DEVELOPMENT ASSESSMENT REPORT

Application No.	DA/2023/0426
Address	F 14/1-15 Barr Street BALMAIN
Proposal	Change of use from office to residential unit
Date of Lodgement	06 June 2023
Applicant	Andres Suarez Ruiz
Owner	Project Express Pty Limited
Number of Submissions	Initial: 3
Value of works	\$389,300.00
Reason for determination at Planning Panel	Section 4.6 variation exceeds 10%
Main Issues	<ul style="list-style-type: none"> Adverse impacts on streetscape and Heritage Conservation Area and inconsistency with desired future character controls Unsatisfactory on-site amenity outcomes Significant variation to Floor Space Ratio development standard applicable to the site
Recommendation	Refusal
Attachment A	Reasons for refusal
Attachment B	Plans of proposed development
Attachment C	Section 4.6 Exception to Development Standards
Attachment D	Statement of Heritage Significance
Attachment E	Conditions in the event of approval

Figure 1: General shape of the mixed-use building, black border, at 1-15 Barr Street, Balmain. Approximate location of Unit F14. In red border is the roof demolition to be replaced with a raised roof, and in green border, is the proposed roof demolition to be left open.

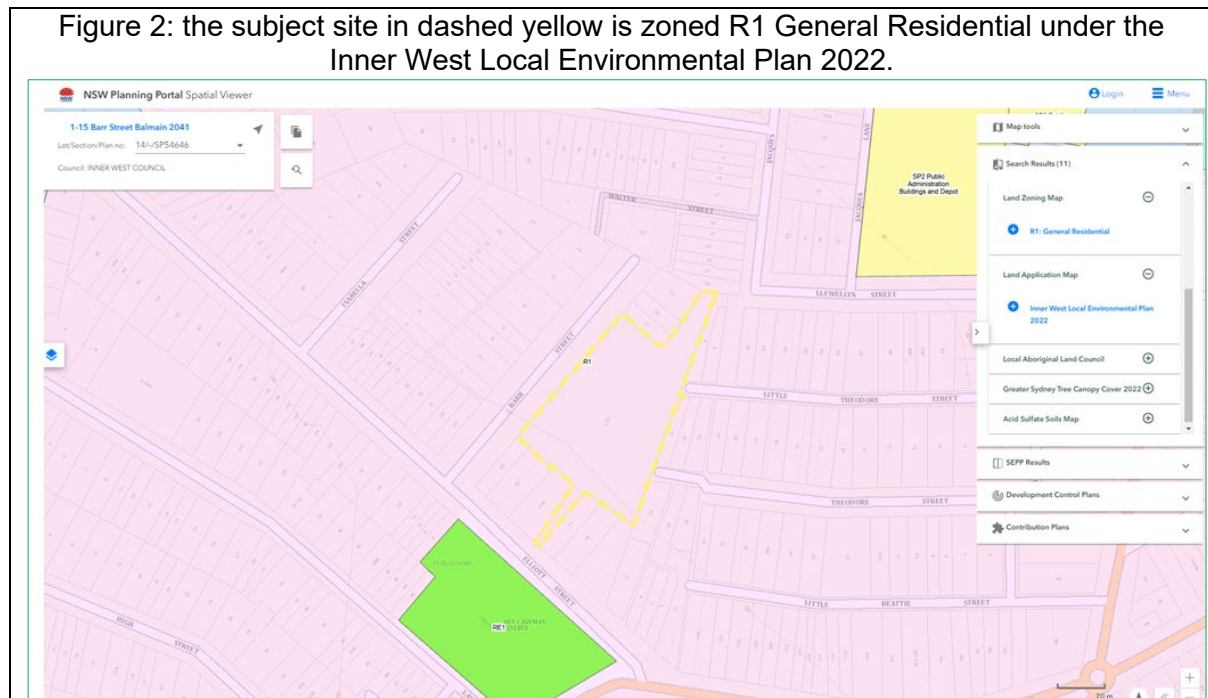
* The mezzanine level proposed within the unit space of Unit F14 is technically an additional storey as it is a "space within a building that is situated between one floor level and the floor level next above, or if there is no floor above, the ceiling or roof above" pursuant to the *Inner West Local Environmental Plan 2022 (IWLEP 2022)*. It does not fit the definition of mezzanine being an intermediate floor within a room.

- The second floor / mezzanine addition increases the proposed roof height by 1.106m and is not contained with the building envelope of the existing building as it extends outside the existing roof form. This is of concern given its resultant visibility from the public domain and given the existing building is already substantially larger than the predominant form and scale of existing buildings in the street and vicinity of the site, and the resultant increase in height, bulk and scale will be out of character in its context.
- The proposal does not provide private open space which receives adequate solar access or acceptable residential on-site amenity.
- The development represents an unsatisfactory departure from a suite of applicable planning controls.

Figure 3: D/2008/406 Approved/Stamped Site Plan Demonstrating the siting of F2 to F4.

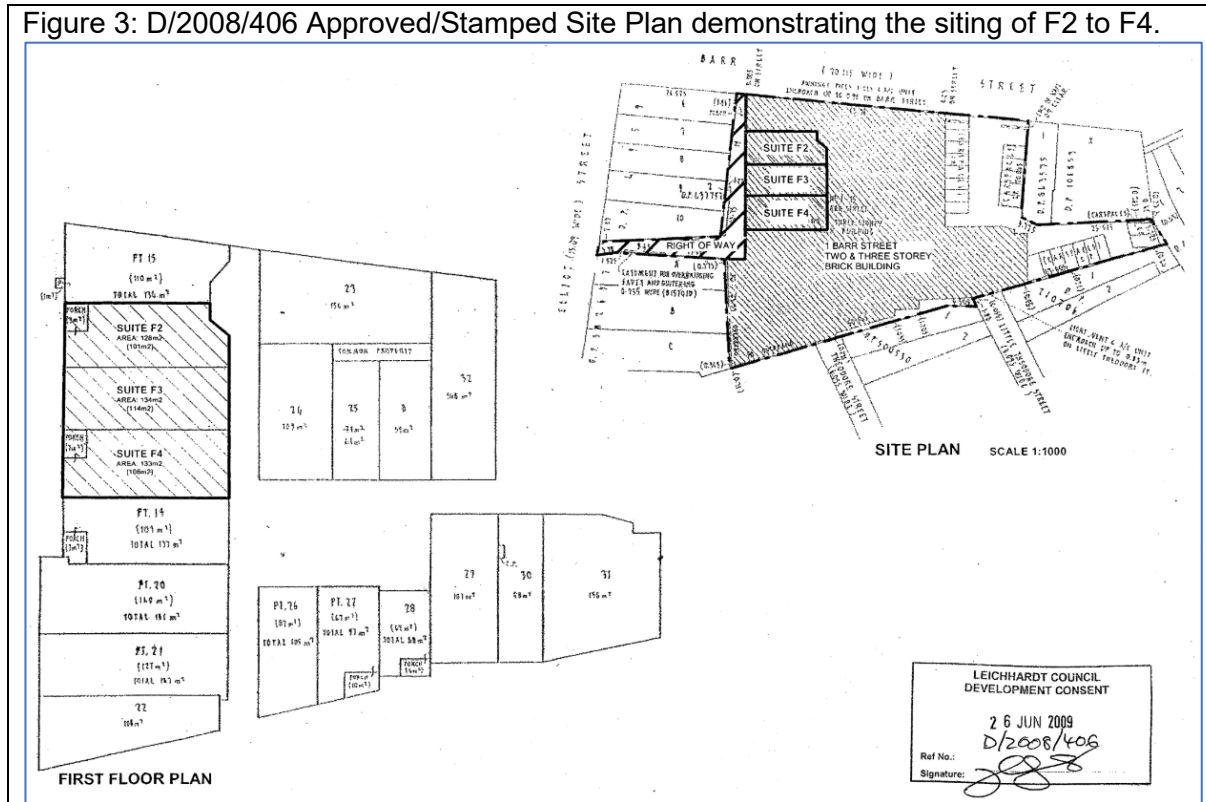
Comment: There are three residential units within the building, and all of which are located contiguously on the south-western side of the first floor. These flats are Units F2, F3, and F4 and are legally described as Lots 16, 17 and 18 in SP54646 with Lot 16 being most westerly and Lot 18 being most easterly. These units are located between Lot 15 to west and Lot 19 to the east. See Figures 3, 4 and 5.

The proposed development does not satisfy Objective 4A-1.1 and 4A-1.2 of this part of the ADG.

Figure 5: Approved fenestration to Flats 2 to 4 under D/2008/406

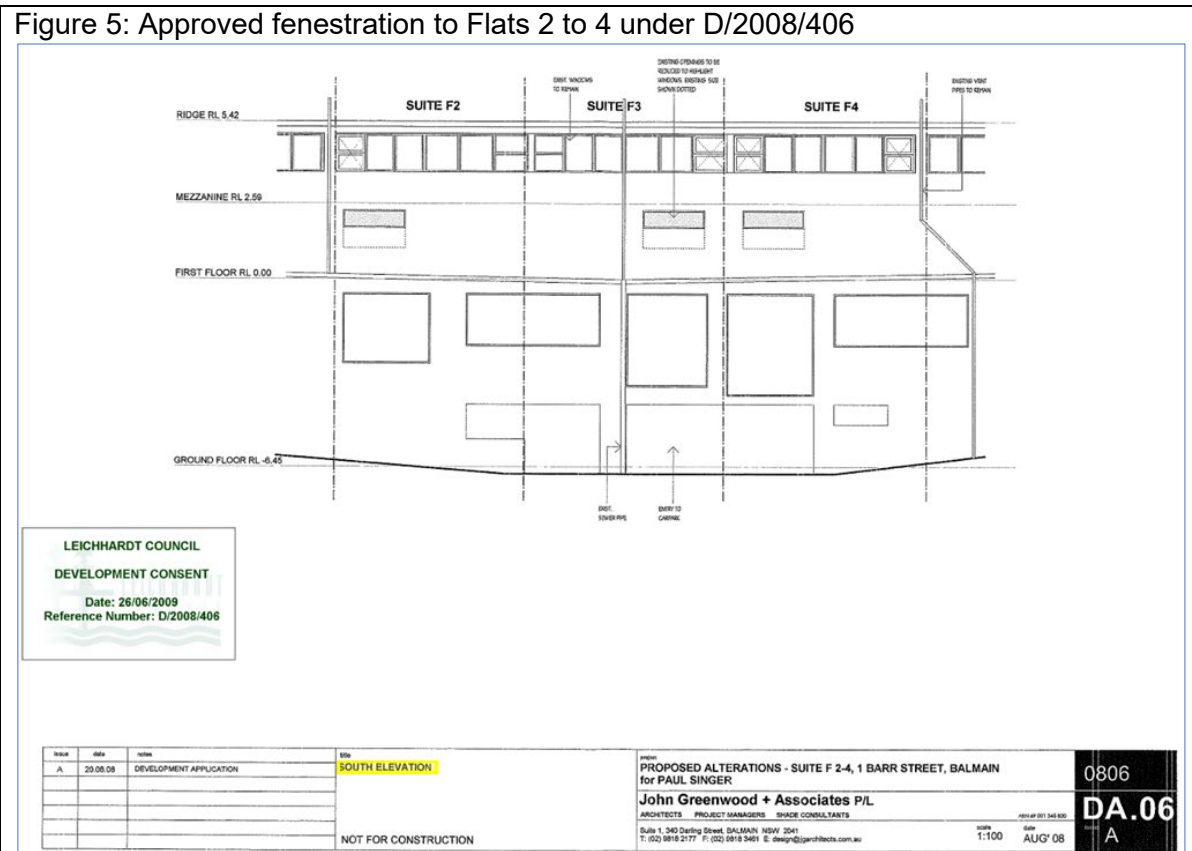
Comment: Existing Flats 2 to 4 do not achieve natural cross ventilation.
